Appendix G.5
Marine Resources
Information Request #11, 12, 13, 15, 16 and 17
(Disposal at Sea Annex Responses)

Reference: Marine Resources Information Request #11, #12, #13, #15, #16 and #21

Table 1-1 Federal IRs Annex Disposal at Sea Comments
December 12, 2014

Proximity of the Brown Passage Disposal Site to Ecologically Sensitive Marine Areas

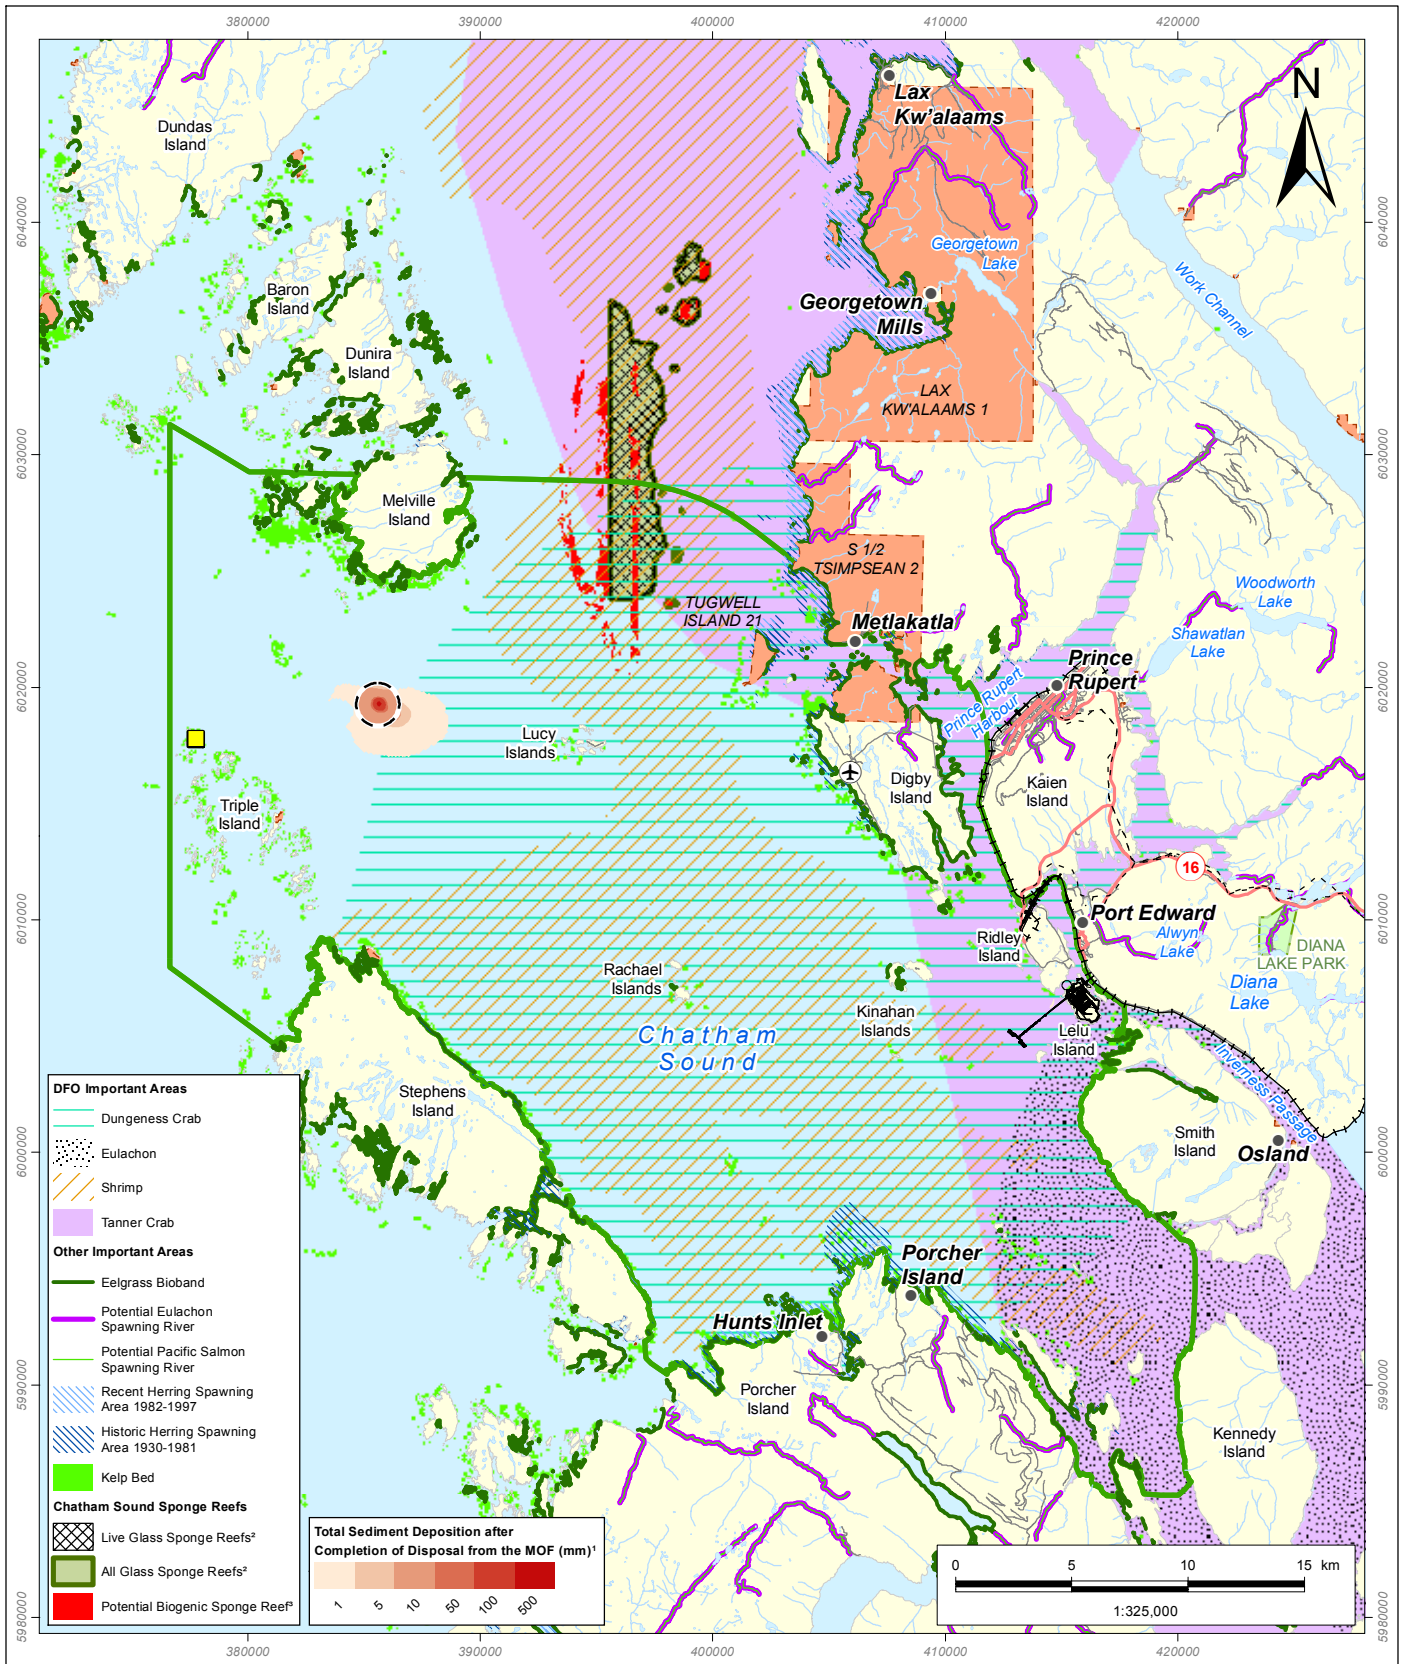
5.3.1.2 (cont'd)	26 (cont'd)	“The site has been used several times since 1972 for disposal of sediment. Given this history and the types of organisms that inhabit deep water with sediment seabeds, it is likely that the habitat at the disposal site and surrounding areas of Brown Passage is resilient to some level of sediment deposition.” (cont'd)		<p>Concern has been expressed over the limited amount of data used in the EIS to characterize the habitats and species present at Brown Passage, as many marine species and habitats are of considerable commercial, recreational and cultural value. To address these concerns, a subtidal remotely-operated vehicle (ROV) survey was conducted throughout Brown Passage in July 2014 (Stantec 2014). Twelve transects, incorporating a total of approximately 53 linear kilometres of benthic habitat, were surveyed (11 km within the disposal site and 42 km outside).</p> <p>Consistent with the assessment within the EIS, the area was dominated by soft bottom substrates with minimal rocky outcrops, and no observed marine plants.</p> <p>The ROV survey also provided additional details on the benthic fauna present within the proposed Brown Passage disposal site and general area. Ratfish and pricklebacks were the most commonly observed fish species. Low densities of rockfish were observed in all surveyed areas (average density for all areas and all species of 0.5 individuals/100 m), with only a single silvergrey rockfish and a single tiger rockfish observed within the disposal site, neither of which are listed under the Species at Risk Act (SARA) or by the Committee on the Status of Endangered Wildlife in Canada (COSEWIC). Furthermore, no large rocky outcrops (the preferred habitat for rockfish) were observed at the disposal site. Halibut were observed in low numbers (0.04 to 0.71 individuals/100 m) throughout Brown Passage, while eulachon were observed only south of the previously used disposal site. Fish species observed within the Brown Passage disposal site radius are expected to exhibit localized short term avoidance of the area during disposal events.</p> <p>The most frequently observed invertebrates were various species of sea stars, pandalus shrimp and scallops. Shrimp may have more sensitive thresholds to sediment deposition, with deposition layers less than 2 cm thick having potential adverse effects on this species. However, shrimp have also been shown to have rapid recolonization rates from surrounding areas (Norkko et al. 1999 in Nicholls 2009). While pandalus shrimp were considered highly abundant during the ROV survey conducted by Environment Canada (2011) at the Brown Passage disposal site, they were not present in high densities within the disposal site in this 2014 survey (average of 3 individuals/100 m). While Brown Passage falls within an area identified by Fisheries and Oceans Canada (2009) as being an important dungeness crab area, no dungeness crab were observed on any of the transects surveyed in 2014. The disposal area, at 200 m depth, is not considered to be important habitat for dungeness crab.</p> <p>Sponges could also be affected by low rates of sedimentation. Cloud sponges were observed throughout the survey area as developing individual sponges, but with no dense reef forming structures observed. Some individuals showed evidence of sedimentation or poor health and occasional dead sponges observed. Within the boundary of the proposed Brown Passage disposal site, cloud sponge structures, present as single, non-reefing individuals, were observed at an average density of 12 individuals/100 m. Sponge density was greatest in the area outside the depositional site but within the modelled deposition area (25 individuals/100 m), particularly to the west of the proposed disposal site. The closest known reef structures are approximately 9 km northeast of the proposed Disposal Site (PRGT 2014).</p>

- Total bottom accumulation 20 days after completion of all dredging disposal from the MOF (as originally modelled in the EIS/Application as 615,000 m³, but scaled to the new dredge volume of 200,000 m³).
- Approximate extent of glass sponge reefs within Chatham Sound as determined by geophysical survey and subsequent ROV inspection completed for the proposed Westcoast Connector Gas Transmission Project (Archipelago Marine Research Ltd. 2014).
- Potential biogenic sponge reef, delineated during benthic habitat mapping completed for the proposed Prince Rupert Gas Transmission Project (PRGT) by McGregor GeoScience Limited on behalf of Stantec (PRGT 2014).

Figure 2: Daily maximum resuspension (in mm) over the model domain during disposal of dredgeate from the Materials Offloading Facility (MOF) at Brown Passage, as previously modelled in Appendix O of the EIS/Application (model outputs captured every 24 hours).

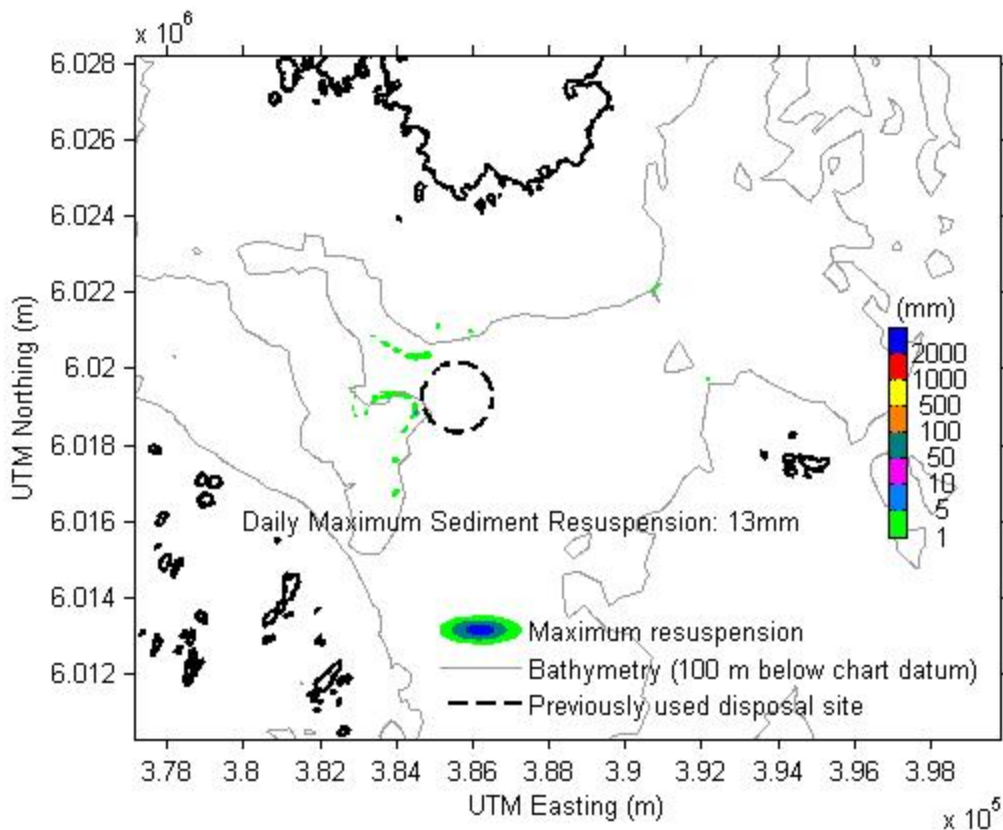
Technical Memorandum- Marine Resources- Effects of Dredging and Disposal at Sea				
		The model addresses the short-term dispersion of material resulting from disposal activity; however, it does not examine the short-term and long-term stability of the dredged material mound subjected to local environmental forcing.	<ul style="list-style-type: none"> Is modelling being conducted to examine the long-term (months/years) fate of the disposal mound? This information is necessary for an understanding of whether the Brown Passage disposal site would be considered dispersive/non-dispersive. 	<p>The modelling of resuspension of the disposal mound was included during the creation of the disposal mound and within 20 days after the completion of the disposal operations from the materials offloading facility (MOF) in the previous modelling simulations (Appendix O of the EIS). The maximum daily resuspension event during the model integration period (January 1 – June 25, 2015) was examined and is presented in Figure 2.</p> <p>Detectable resuspension is located in the deep channel to the northwest of the disposal site and along the 100 m isobath to the southwest. A small amount is also seen about 5 km away to the northeast at 100 m water depth. The maximum daily resuspension is 13 mm at the southwest area of bottom ridges where dispersion would be expected to be more prevalent. Given the very limited areas where erosion is predicted to occur, none of which are within the previously used disposal area, and the small amount of erosion associated with the weak bottom currents, it is not anticipated that resuspension of the disposal mound would amount to appreciable volumes.</p> <p>In order to investigate the potential for long-term resuspension of discharged sediments onto the seabed, the simulation of two extreme model scenarios were carried out in Jiang and Fissel (2010). One scenario involved an extreme wind event and an extreme tidal forcing over a 40 year period which occur simultaneously, and the other involved the extreme tidal forcing condition only. Both scenario cases were simulated for the discharged sediment resuspension over a 10 day period. It is believed that the model results of the sediment resuspension for the first scenario reflect a large upper bound to the actual values of the likely maximum potential resuspension of the discharged sediments on the seabed over a 40 year period, while the model results for the second scenario likely represent a close lower bound to the actual levels of potential resuspension.</p> <p>The model results for these two extreme scenarios show that strong near-bottom velocities, exceeding the critical resuspension velocity for fine-grained sediments (clay, silt and fine sand), only occur in relatively shallower areas where water depths are less than about 100 m. It was also found that the maximum near-bottom TSS values over the 10 day model period are less than 13 – 15 mg/L above background. Near the surface, the maximum TSS values are less than 0.1 – 0.2 mg/L above background during these 40 year maximum resuspension events.</p> <p>To confirm the model inputs for currents at the Brown Passage disposal site, PNW LNG is conducting a metocean measurement program and deployed an acoustic Doppler current profiler (ADCP) at this site on October 15, 2014. This program will span a six month winter period (October 2014 to April 2015), to correspond with the strongest predicted winds, and therefore highest seasonal current speeds.</p>
